ADDENDUM #1
ANDERSON ROAD (M.S.A.S. 198) – HAINES ROAD TO CHAMBERSBURG AVENUE
S.A.P. 118-198-003
CITY OF DULUTH
PROJECT No. 0357TR
BID No. 12-02DS
Bid Opening: February 16, 2012

NOTICE

W-18

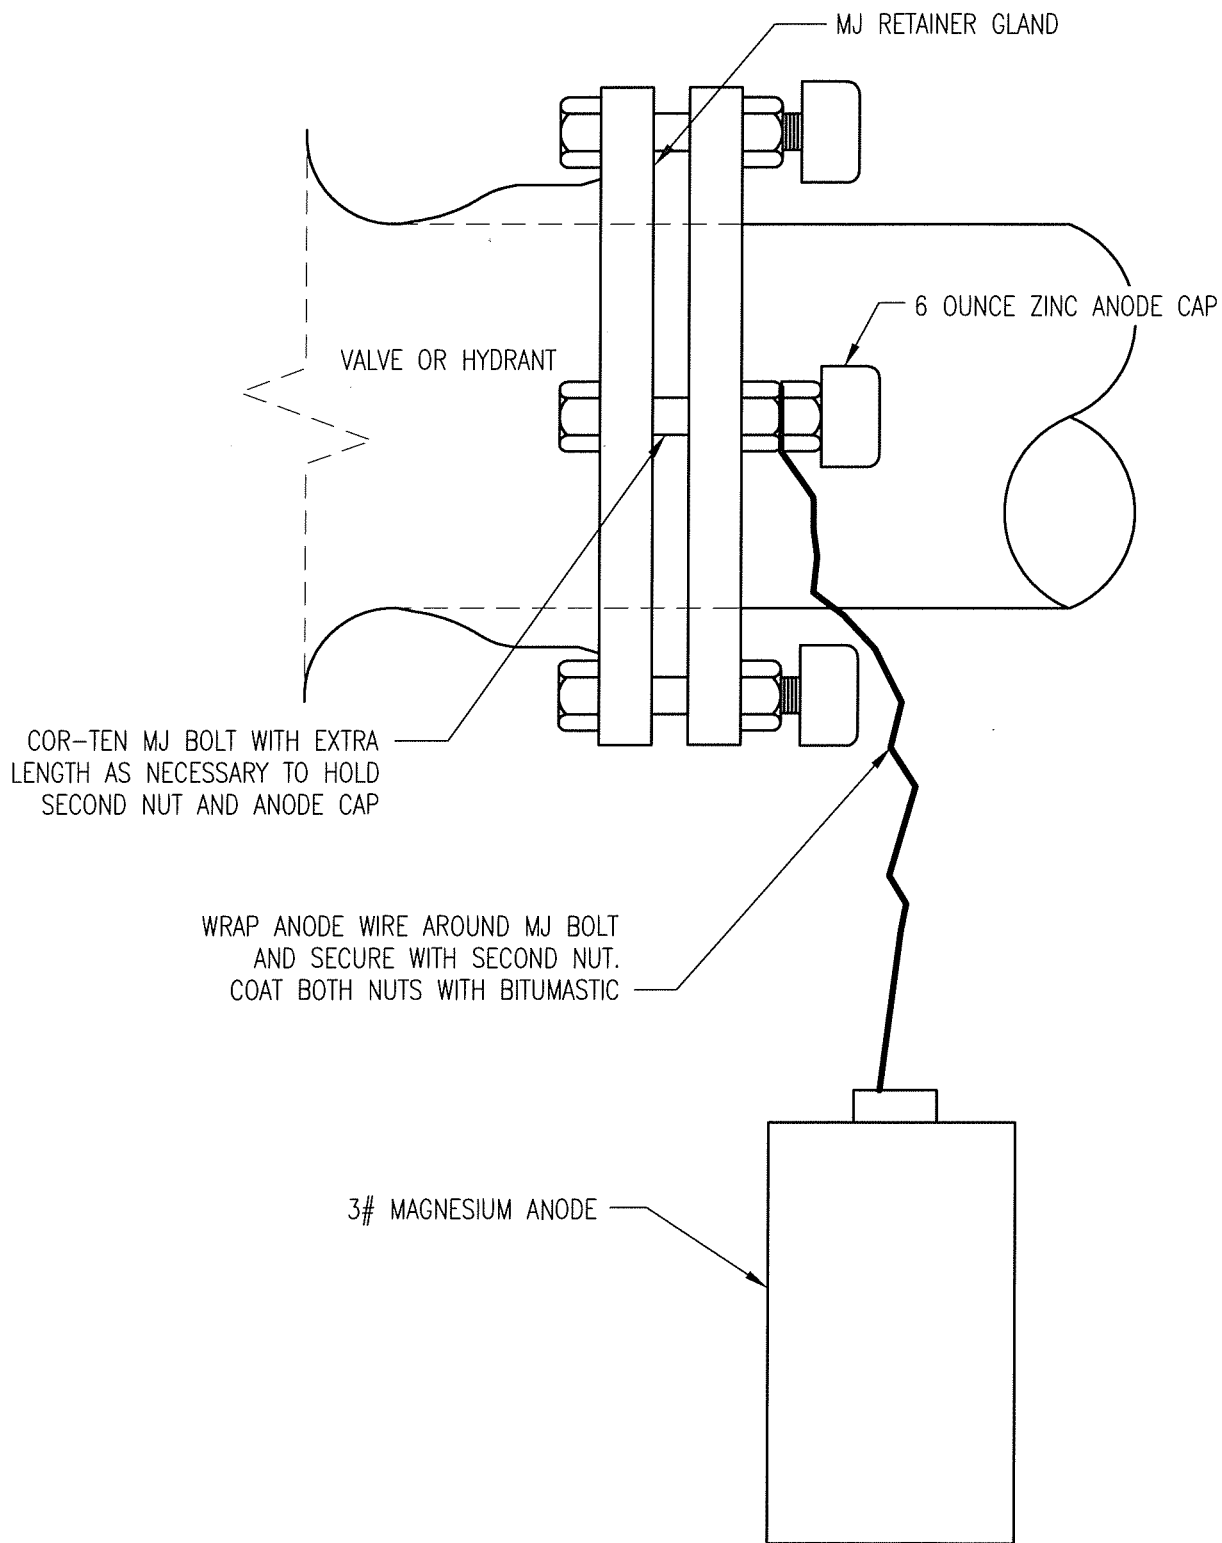
7. **ADD** detail drawing W-18 Anode Connection (attached) to project.

- g) Magnesium Anode. All hydrants and valves shall have a 3 pound magnesium anode attached to one of the mechanical joint bolts. Refer to standard detail W-18.
